RE: Case 20-13P, Rezoning of 41.031 acres on Mason-Morrow-Millgrove Road; and
Case 20-14P, Preliminary Development Plan for Redwood USA, LLC on Mason-Morrow-Millgrove Road

Staff Report for the Preliminary PUD Plan for Redwood- Kim Lapensee

Subject
Summary of Review #1
Redwood Apartment Neighborhoods Zoning Amendment and Preliminary PUD Submittal
South Lebanon, Ohio

Ref: Redwood South Lebanon project.

**PRELIMINARY
DEVELOPMENT
PLAN**

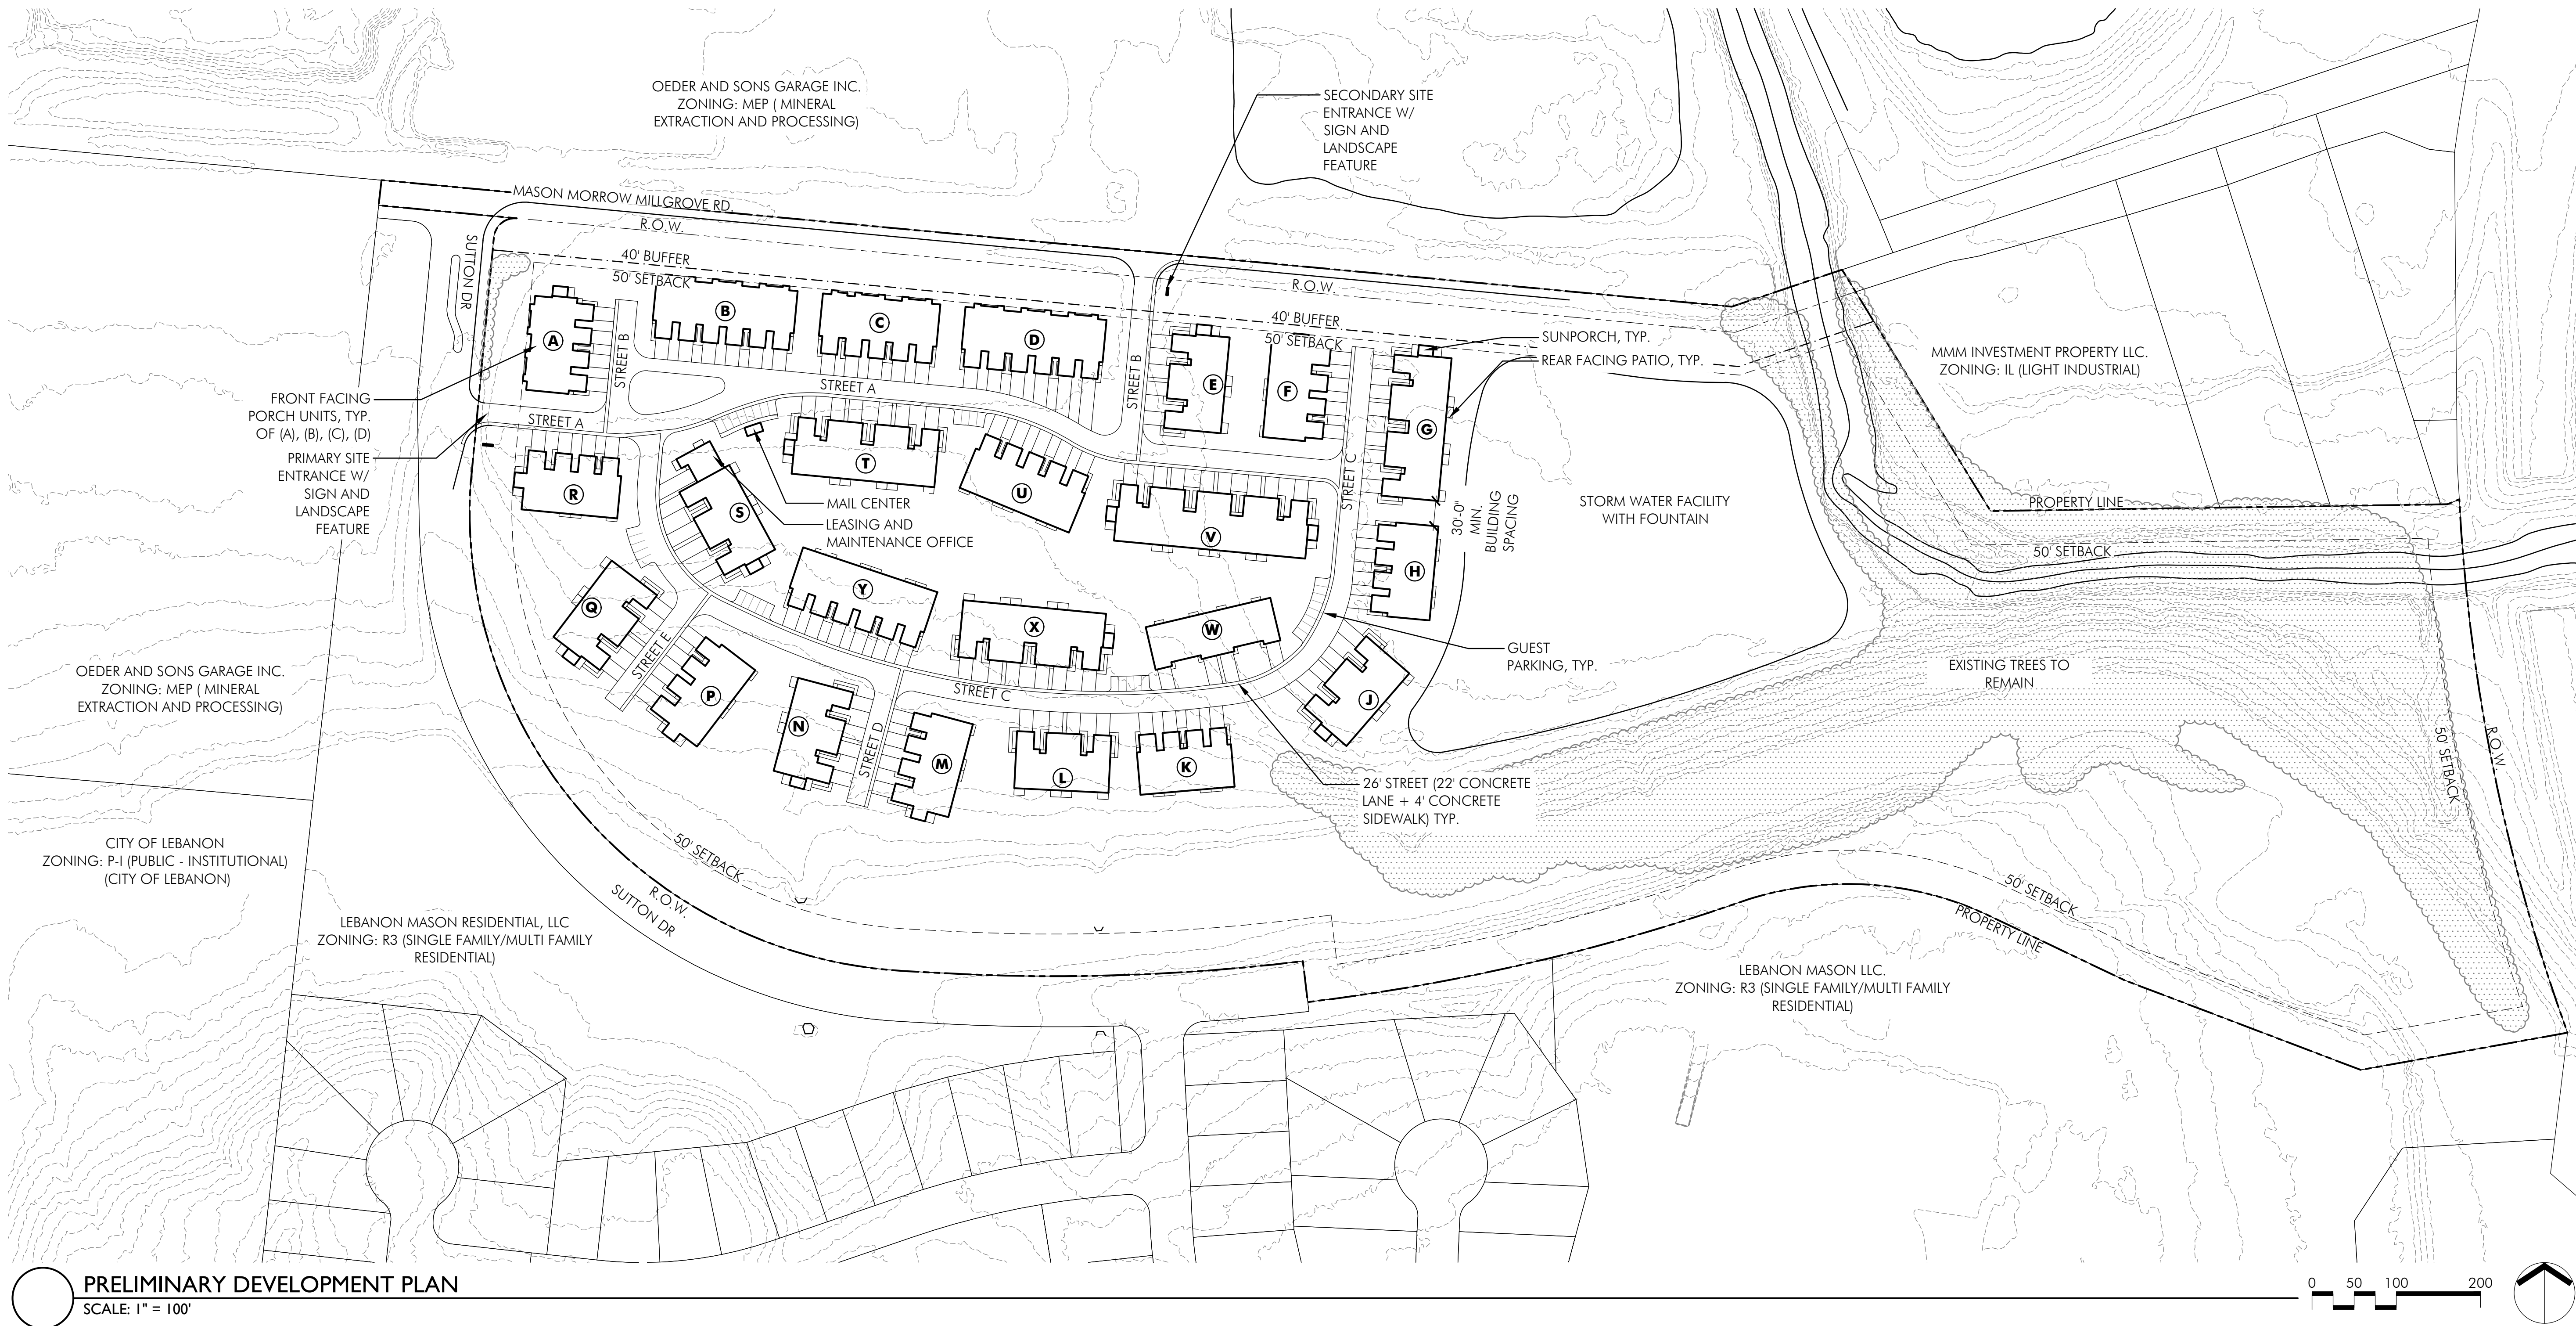
The PDP shows a secondary entrance on Mason-Morrow-Millgrove Road West of the main Sutton Avenue entrance. Due to the close proximity to Sutton Avenue, Staff recommends that this entrance be deleted from the plan.

- A full access drive would be discouraged for the 2nd access to the development. If that is full access, it seems every single driver coming from the east would turn left into this development where there is no left turn lane. It would be preferred if the 2nd access was a right-in, right out only. If the developer insists on that being full access, we'd want to see new traffic counts and a turn lane analysis to support that would not affect the level of service of the roadway.

1. There are adequate Fire hydrants, 1-2 at each unit.
2. The entrance/exit onto Mason Morrow Millgrove Road is a concern due to the traffic flow especially in the evenings. has a "Traffic Study" been done on the road? If so, may we get a copy?

1. Removal from PDP of secondary entrance on Mason-Morrow-Millgrove Road;
2. All streets within this development will be privately maintained;
3. Comply with PUD buffering requirements per the Village Zoning Code;
4. Meet Village and FEMA floodplain permitting requirements;
5. Address the questions/comments of the Union Township Fire Department.

Sheet Title
PRELIMINARY LANDSCAPE PLAN

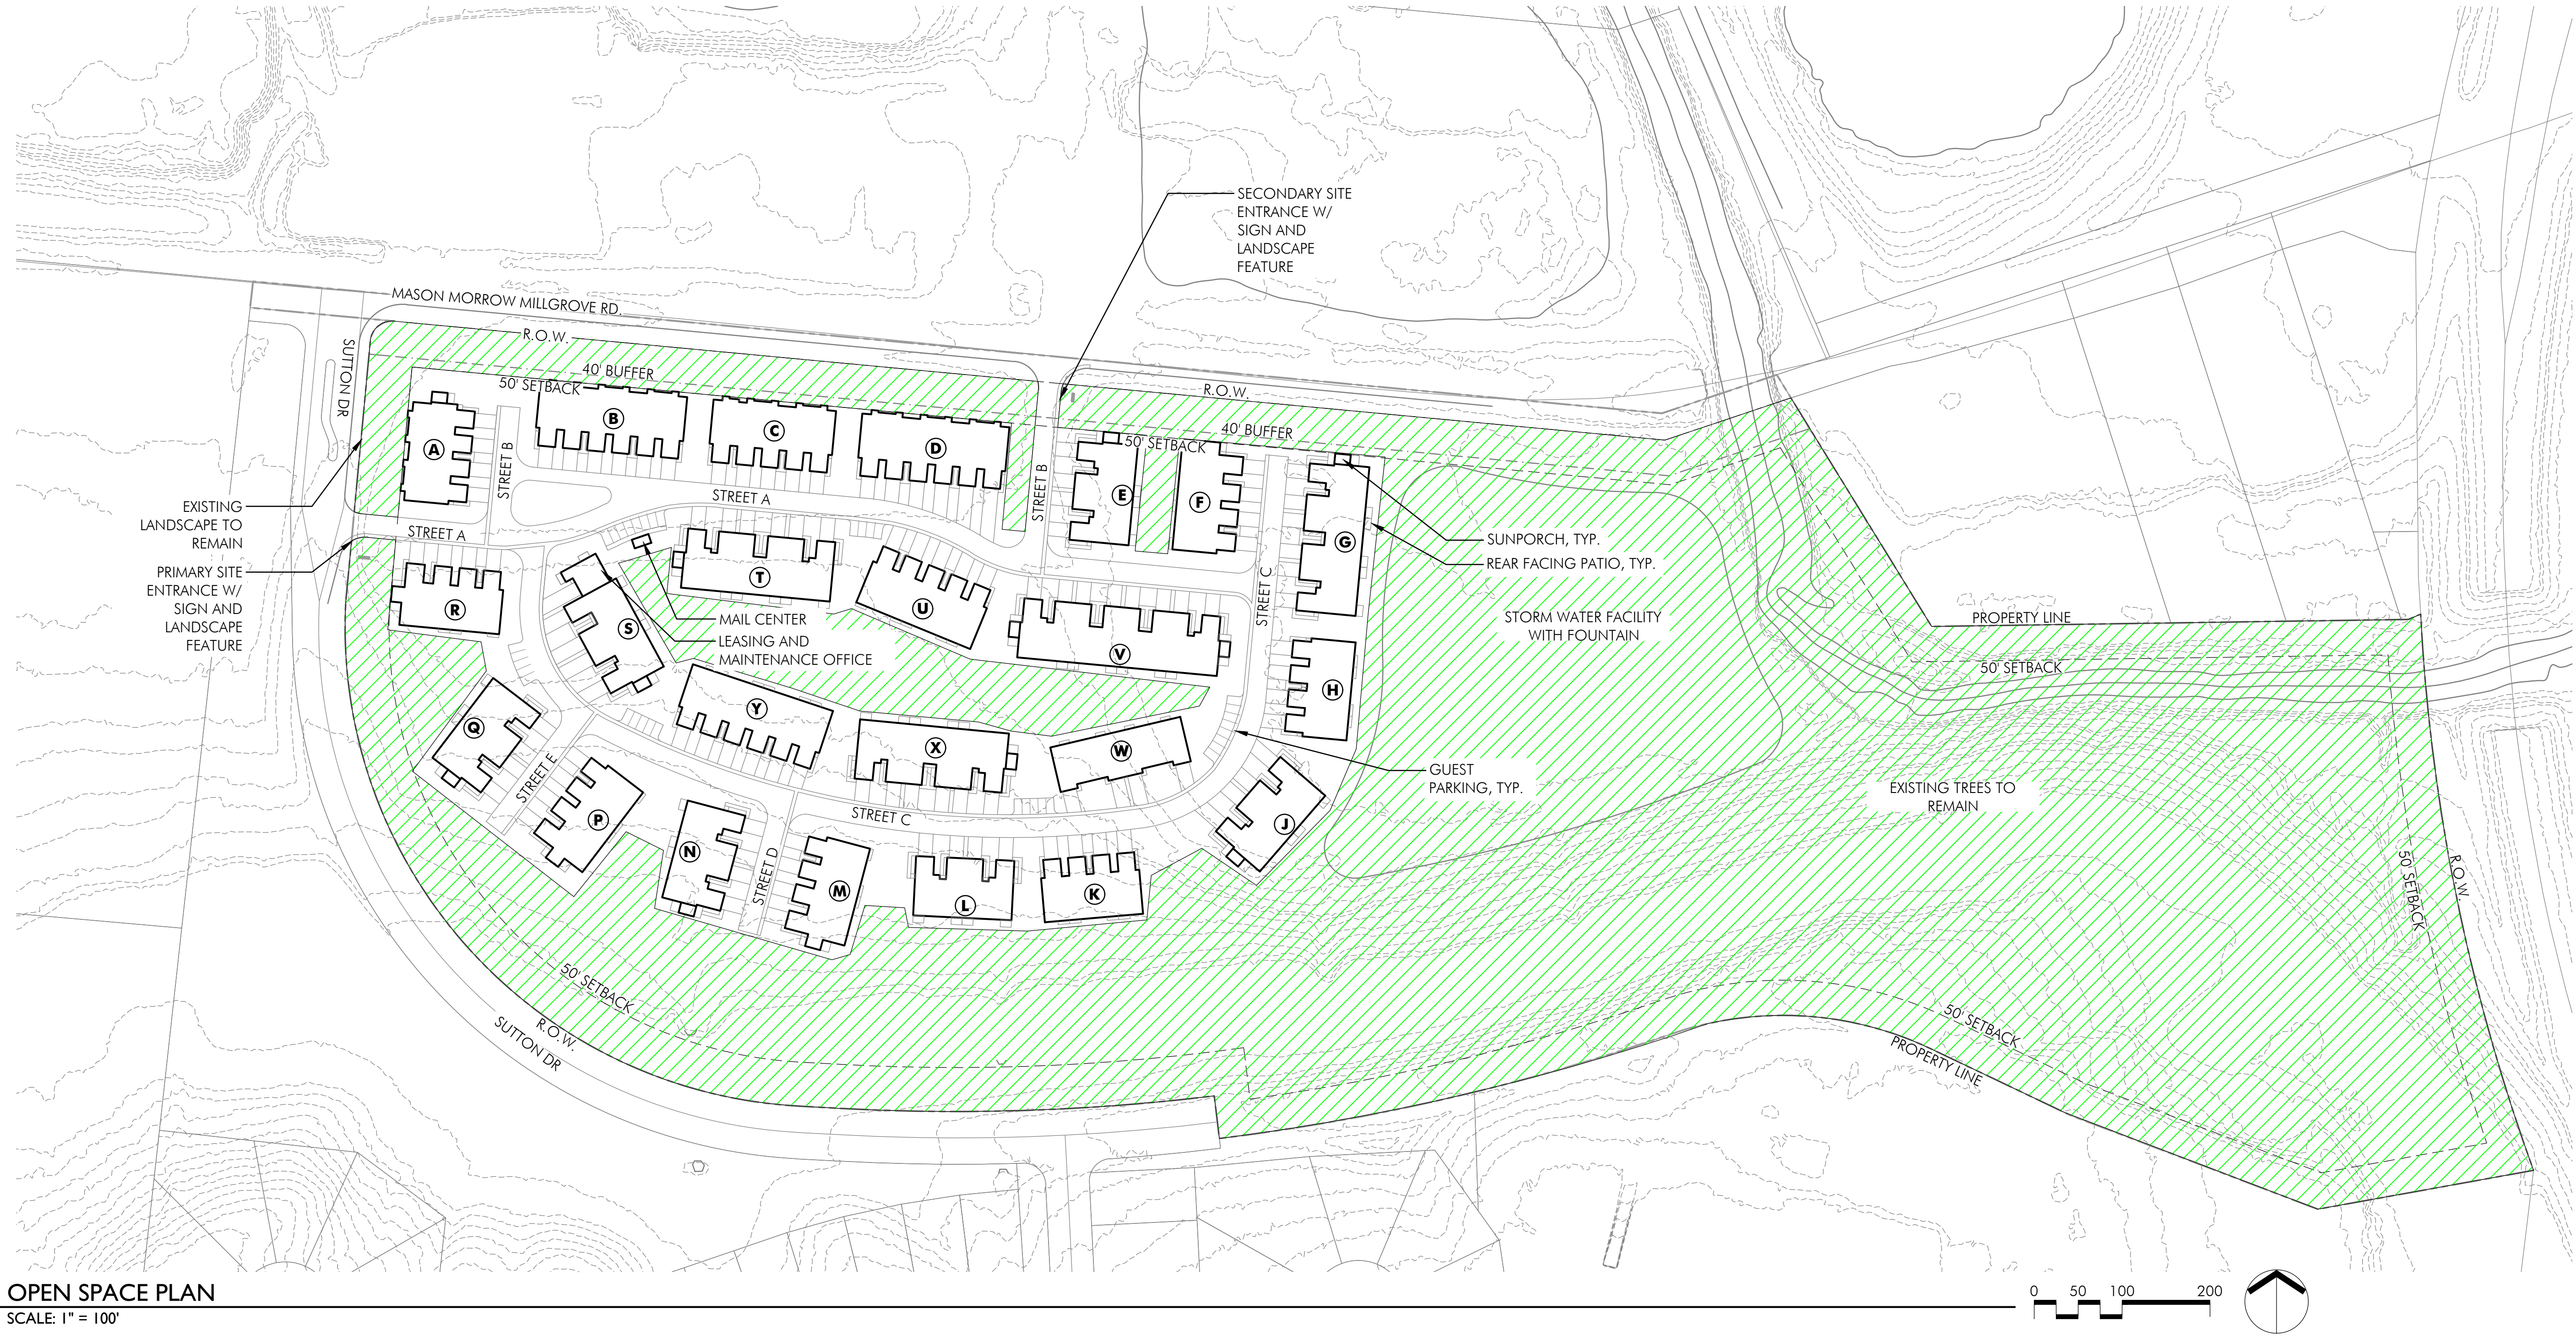
- Buffer width shall be a minimum of 10'-0" wide. **None required.**
- Continuous screen provided 30" high consisting of an earth mound, planting, hedge or decorative wall or any combination thereof. **None required.**
- One deciduous tree shall be required for every 30 lineal feet of the required buffer zone – Screen areas where parking abuts the property lines. **None required.**
- The property is adjacent to an industrial zoning and will require a 30'-0" buffer that is 6'-0" tall and 1 tree per 20 lineal feet shall be planted of which 50% must be evergreens to buffer the difference in uses. **There is roughly 700 lf to the west and 400 lf to the east that requires a screen. 35 trees will be required to the west and 20 trees to the east.**

- Screening shall be provided along Mason Morrow Millgrove Road a minimum of 40'-0" wide, 6'-0" tall and 1 tree for every 20 lineal feet. ***There is 1,622 lf along Mason Morrow Millgrove Road – $1,622/20=82$ trees. There are 83 trees provided along MMM Road.***

- Easements for the water/sewer will be needed if the development wants those things to be publicly maintained.
- Nice screening such as mounding and/or evergreen trees should be required along MMM Road to separate the units from the roadway.
-

PRELIMINARY
SITE & UTILITY
PLAN

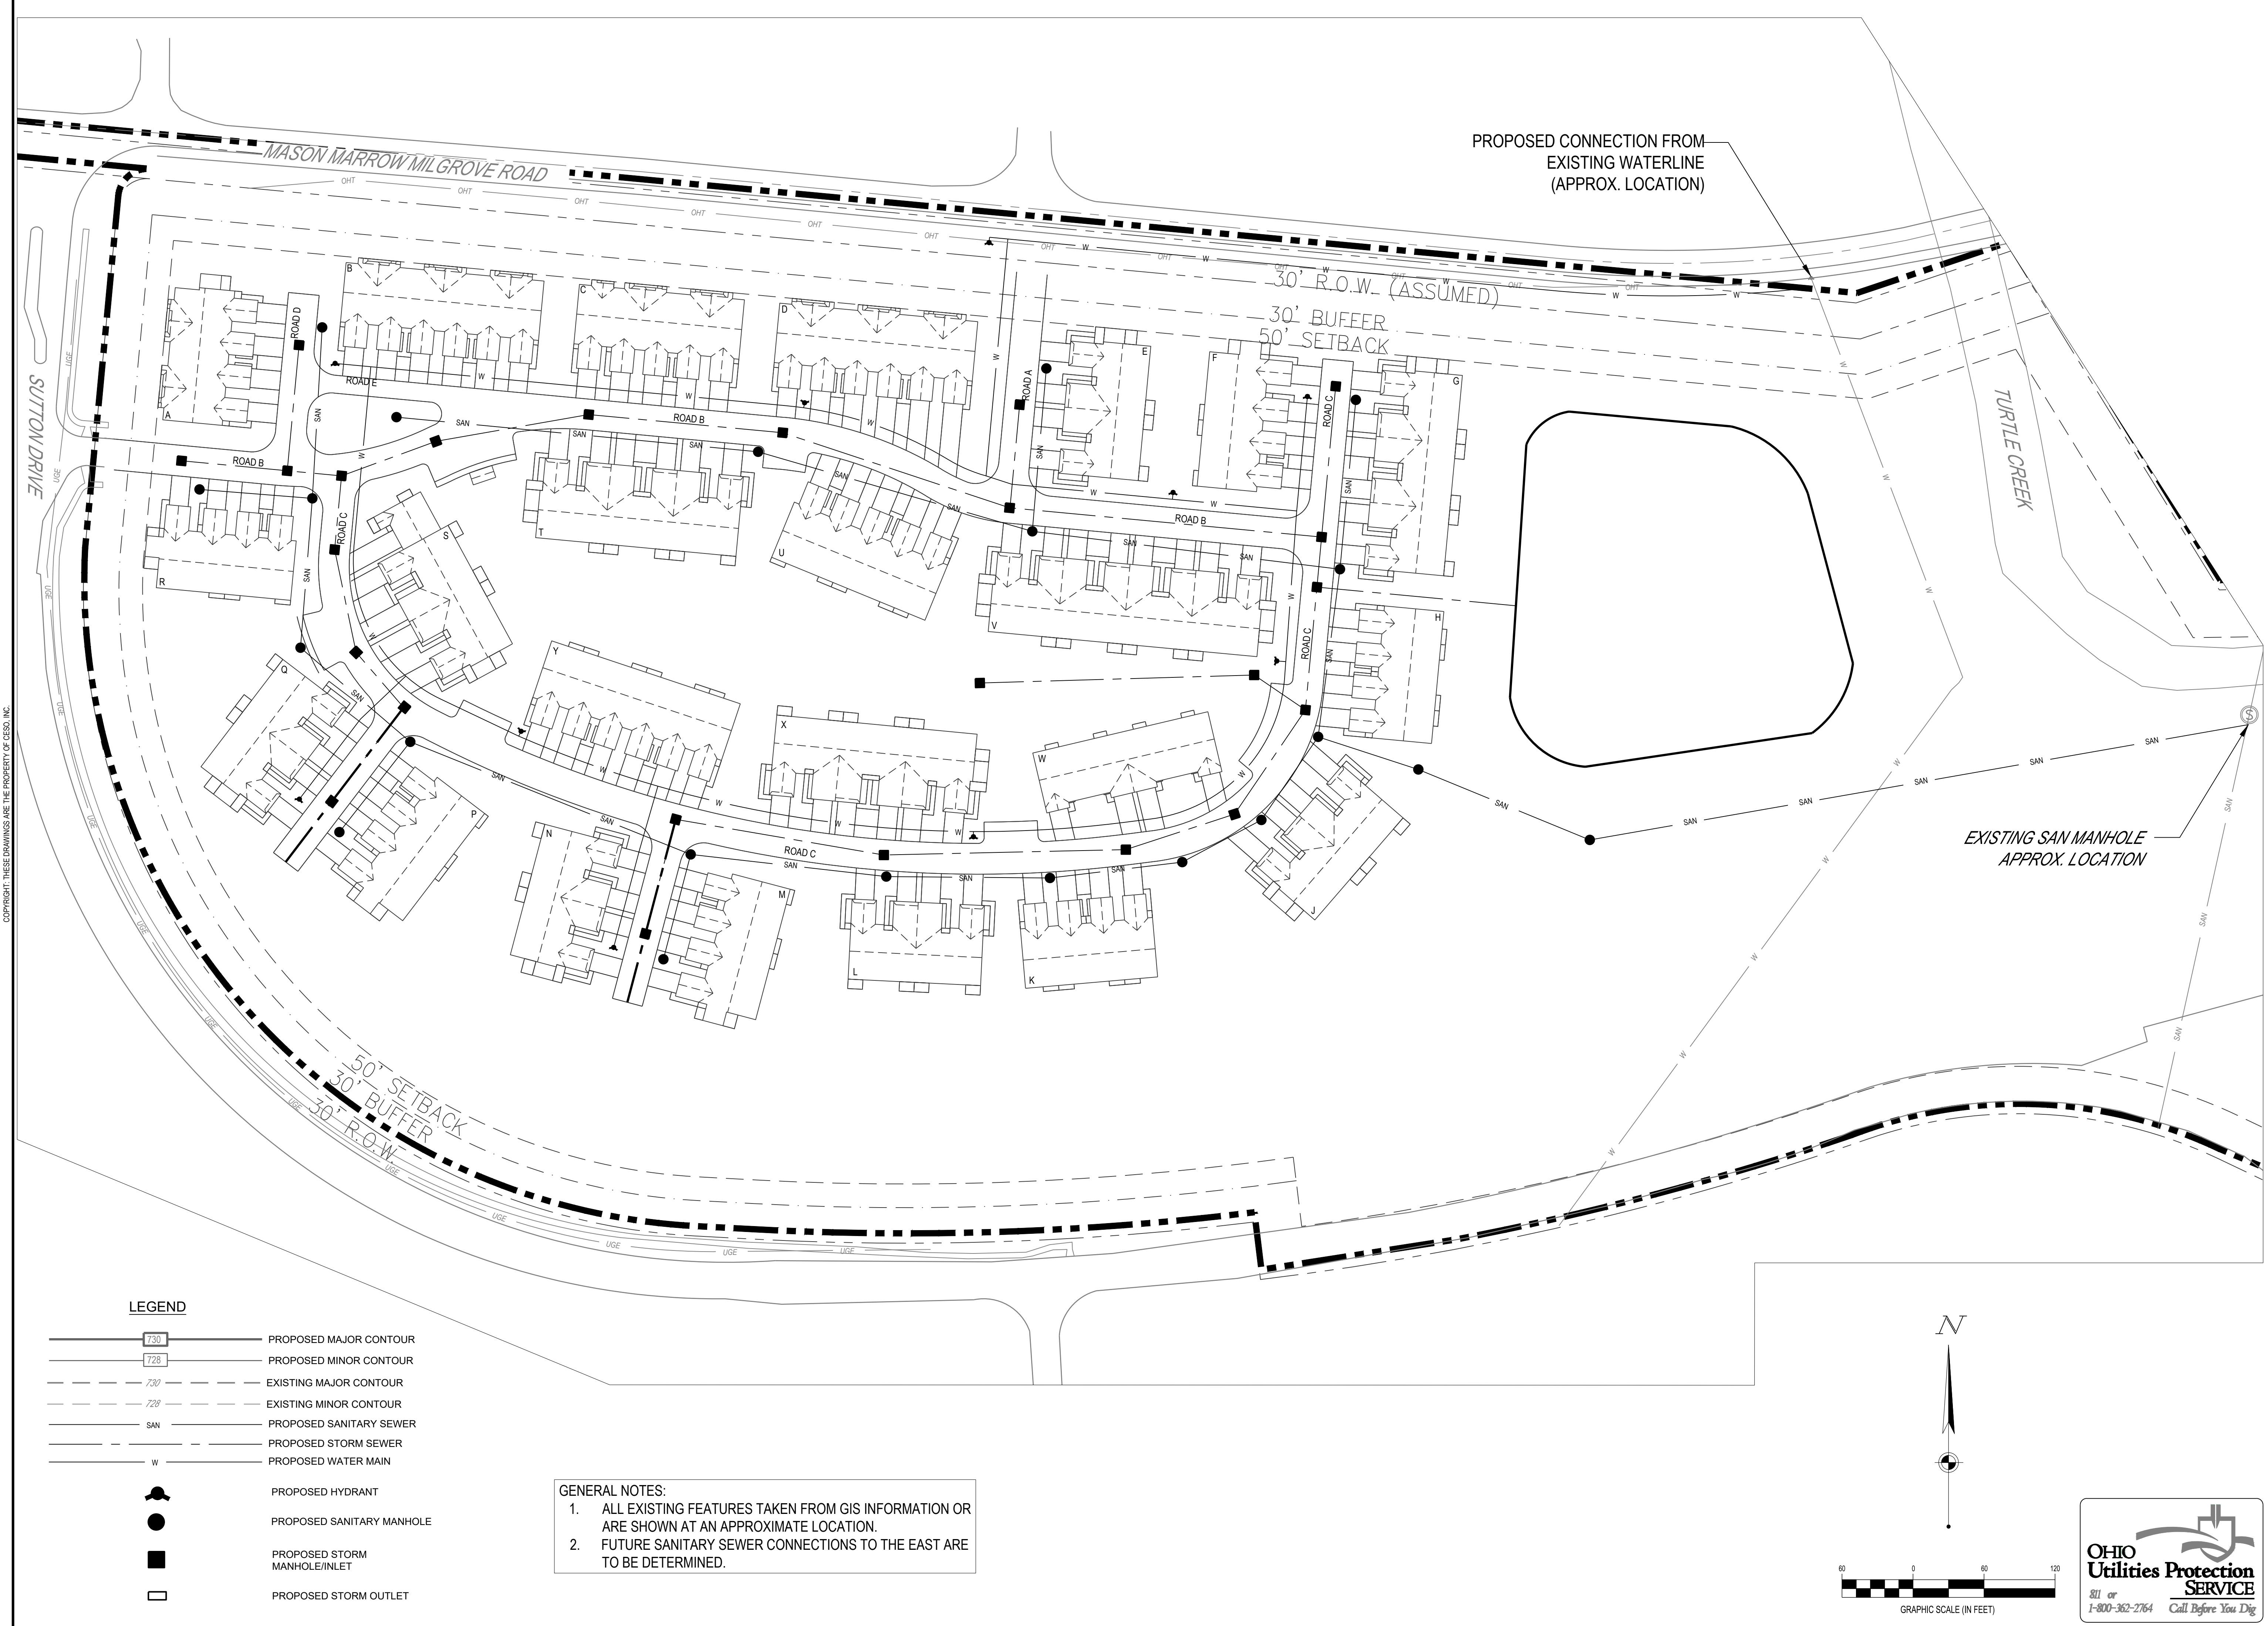
- It would be better if the developer didn't cross MMM Road with a waterline. They should tap the existing water main on the south side of MMM Road and run it along the south side of the road, probably within the new R/W they need to dedicate. They'll need to ensure the water main doesn't go under any portion of their pond either.
